**Section 16 Planning Application for Proposed Minor Relaxation of  
Building Height and Plot Ratio Restrictions  
for Permitted Public Housing Development at  
Long Bin, Yuen Long  
(Application no. A/YL-TYST/1285)**

**S.16 Application No. A/YL-TYST/1285**

**Responses to Comments**

DRAWING TITLE  
**INDICATIVE LANDSCAPE MASTER PLAN (All levels)**

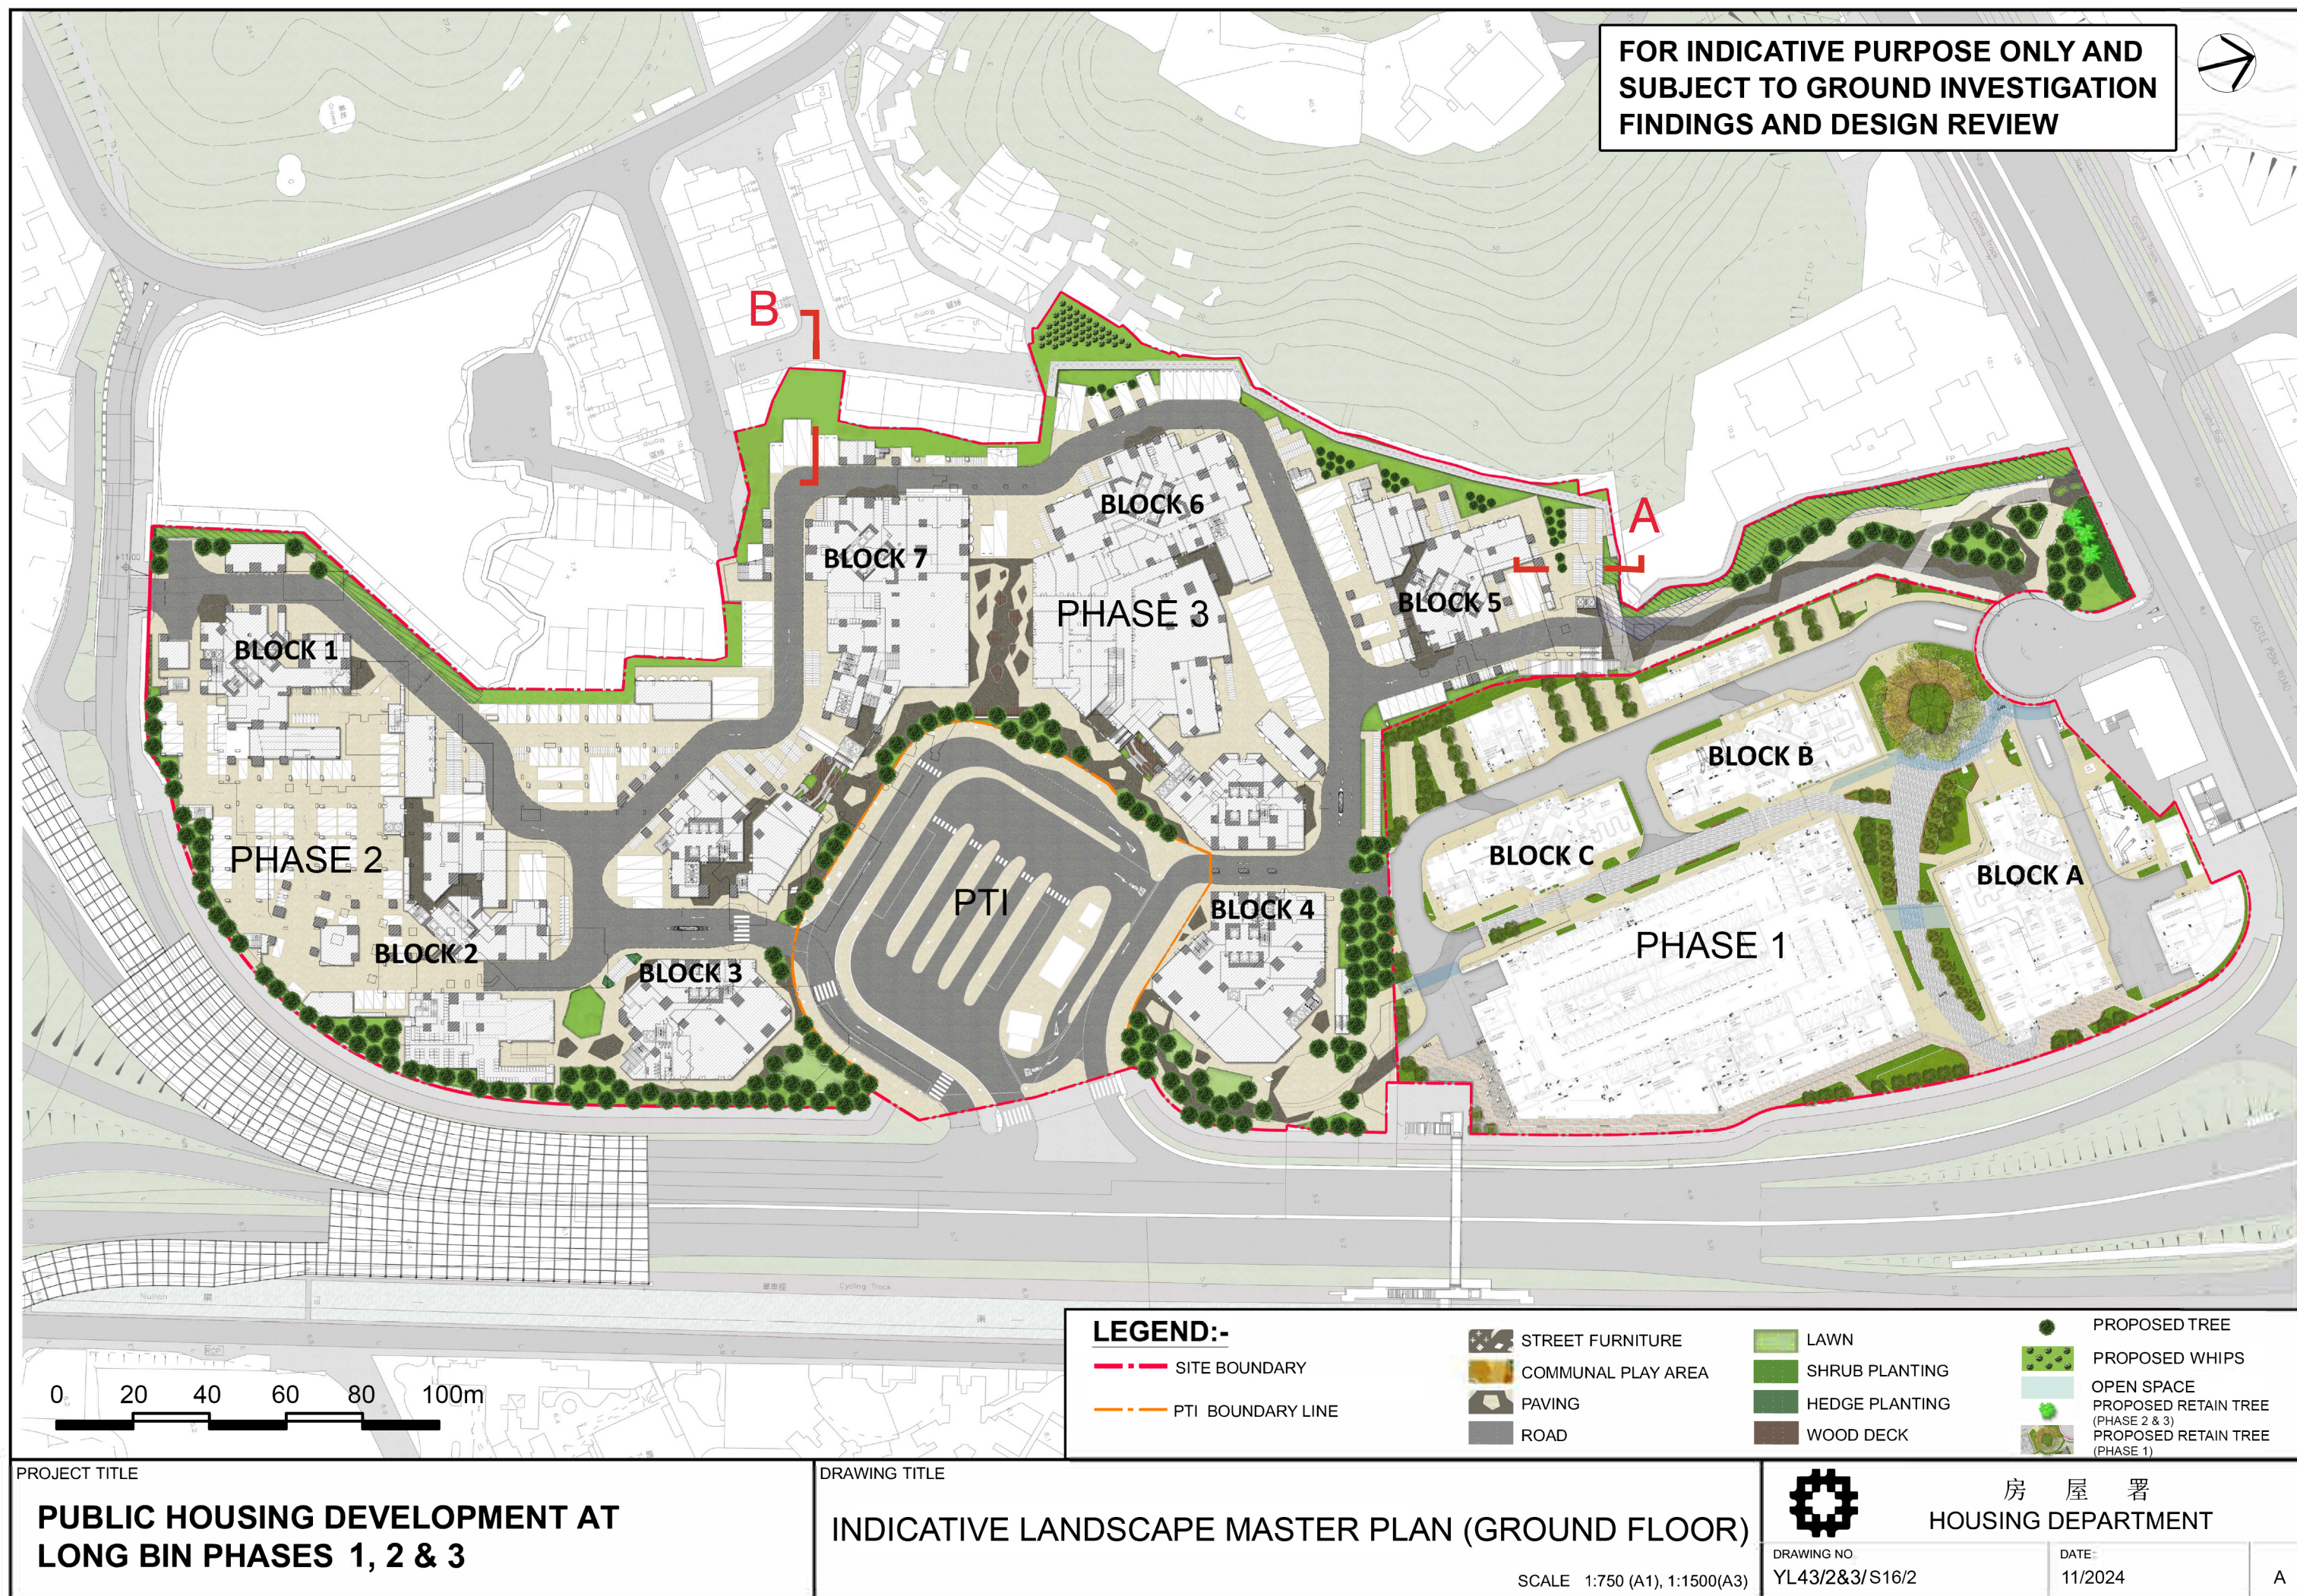
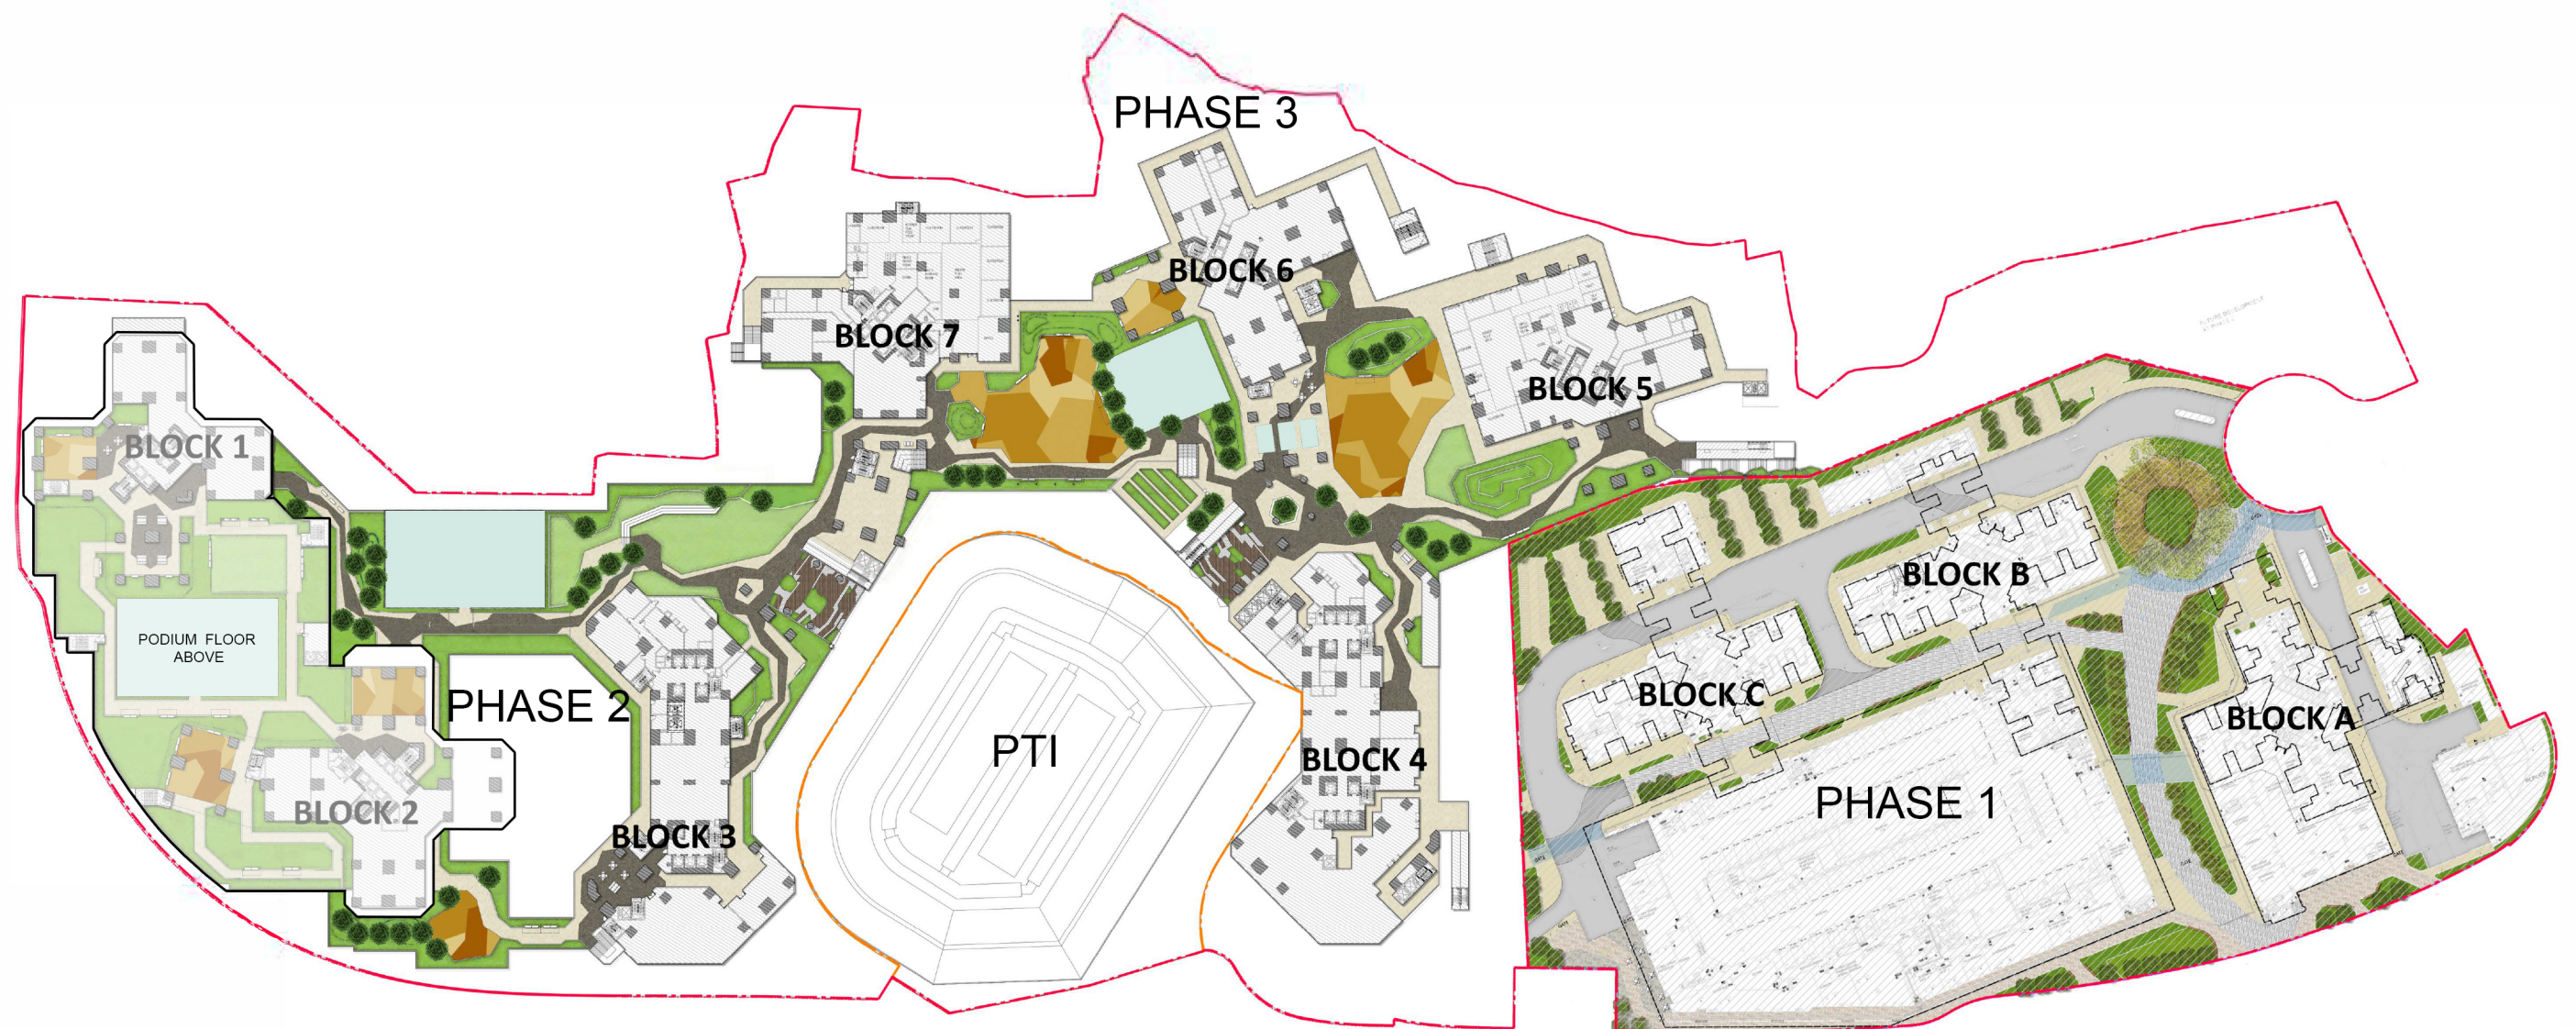
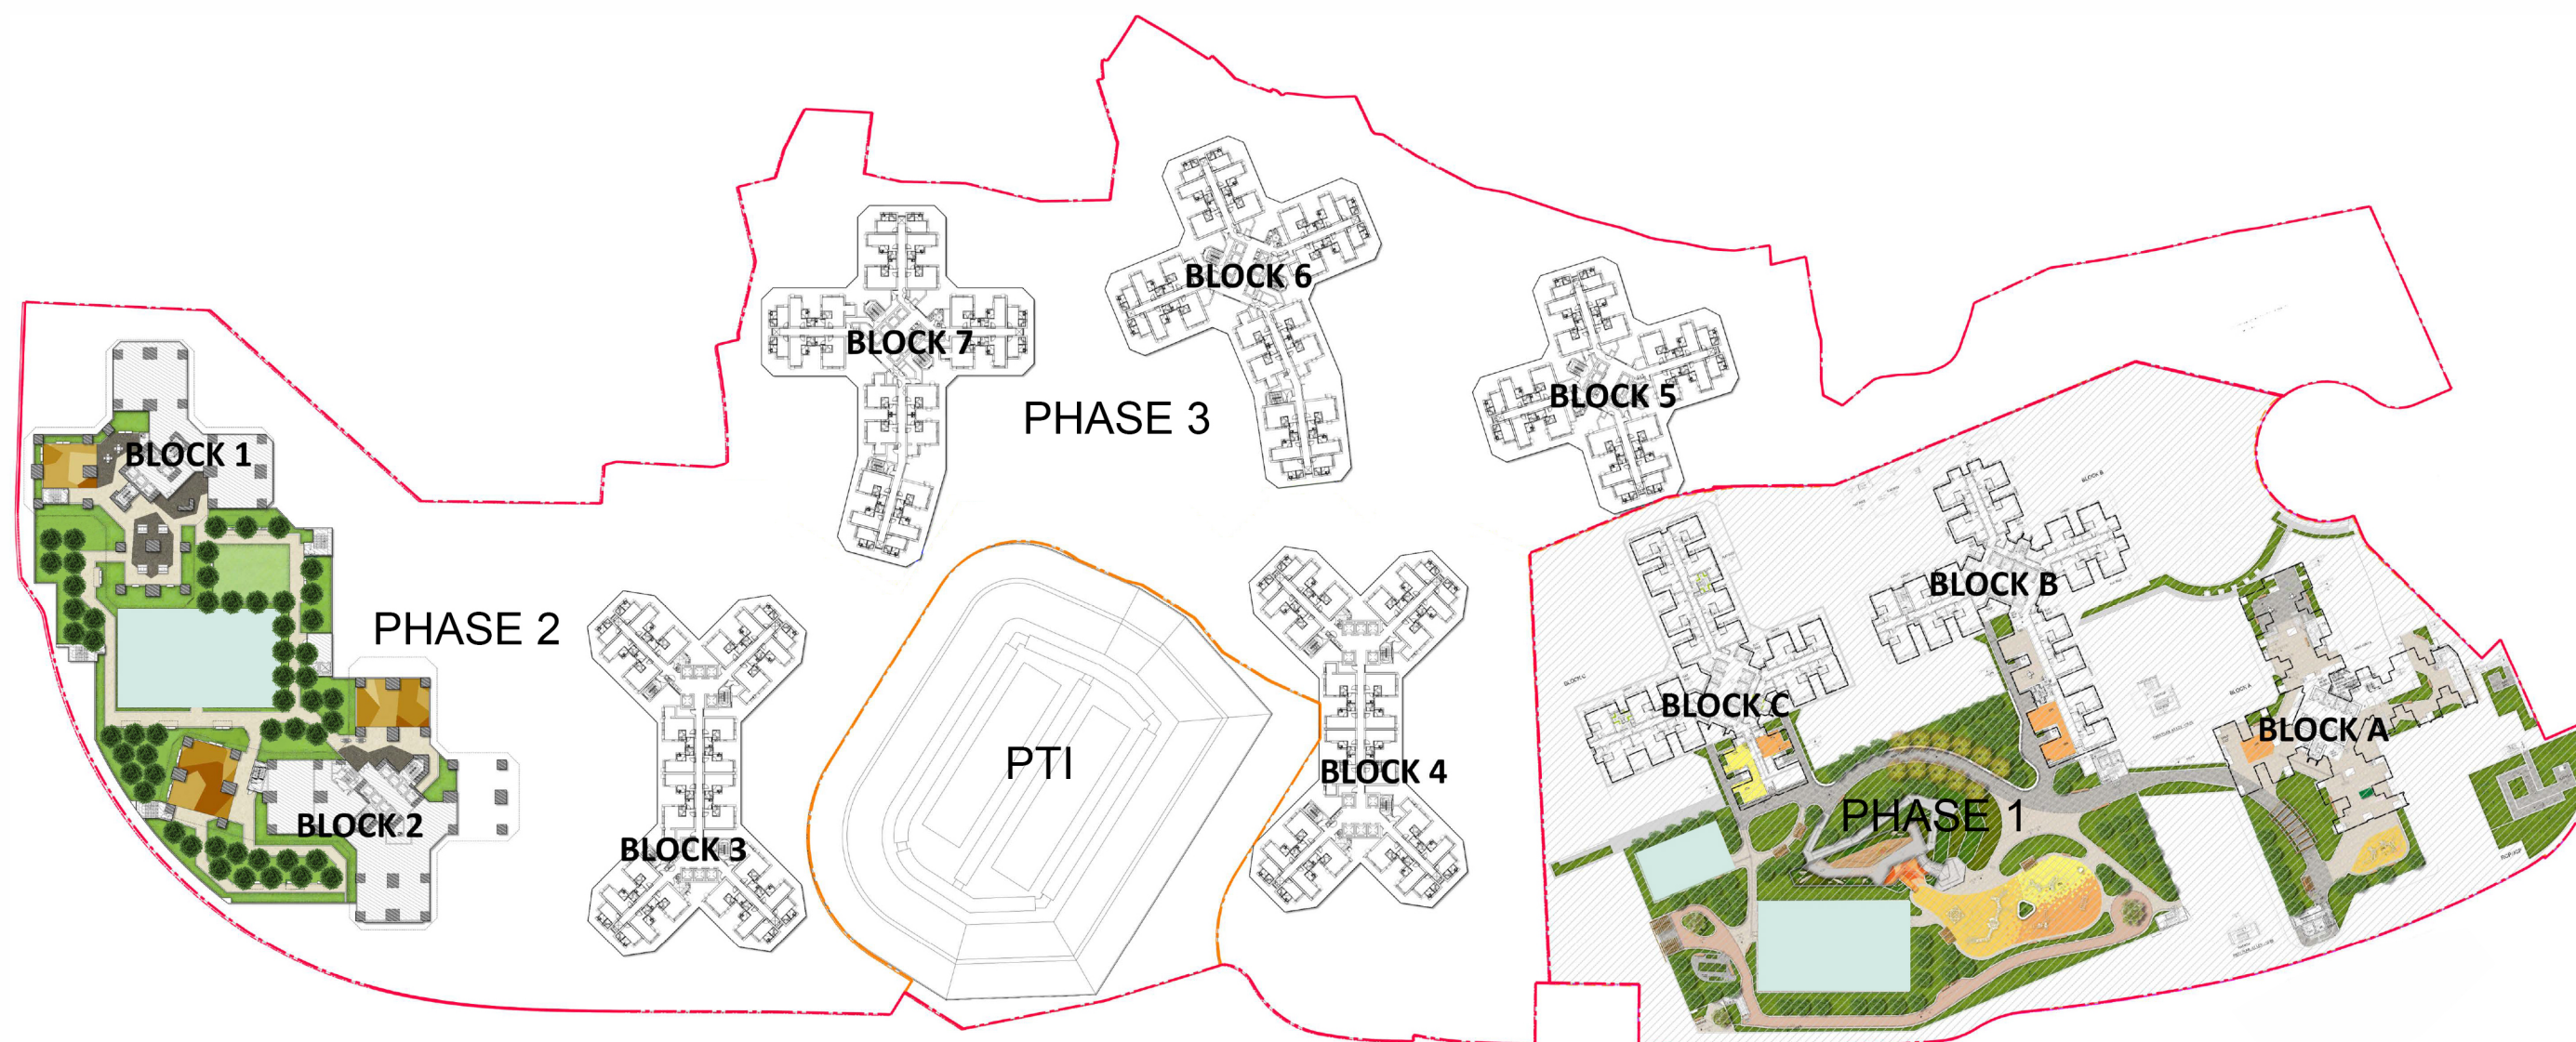
(c) Please provide scale bar on the Indicative Landscape Master Plans.	Noted. Please refer to the revised Indicative Landscape Master Plans (Figures 5 to 8) in <b>Attachment 4</b> .
